Application No. 10/536,477
Amendment Dated January 14, 2008
Reply to Office Action Dated August 27, 2007

Amendments to the Drawings

FIG_5

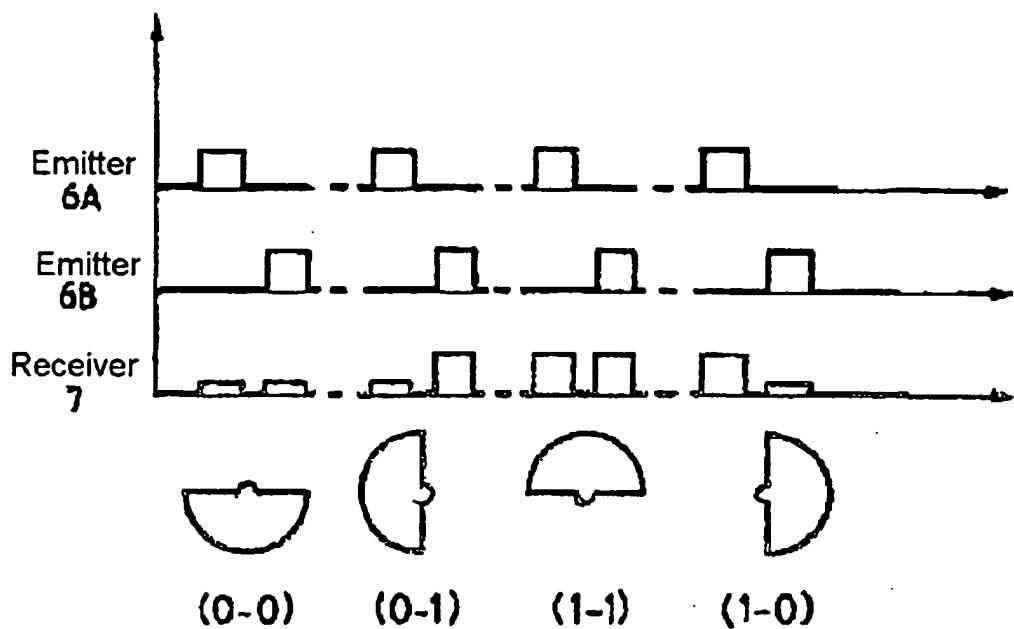
In paragraph 1 of the Office Action, the Examiner has objected to the Figures and claim 9, because the optical collimator device having slits is not shown in the drawings. Applicants have amended Figure 5 and corresponding paragraph [0053] of the specification to show slits 9 in the collimator device. Such amendments to the specification and Figure 5 do not constitute new matter because the slits 9 in collimator device 8 were adequately described in the application as filed in both originally filed claim 9, and paragraph [0018] (beginning on line 21 of page 3) of the specification. In view of these amendments, Applicants request that these objections be withdrawn.

The attached sheet of drawings includes changes to Figure 5. This sheet 3/5, which includes Figure 4 and 5, replaces the original sheet 3/5 which includes figures 4 and 5. In Figure 5, the previously omitted item 9 has been added.
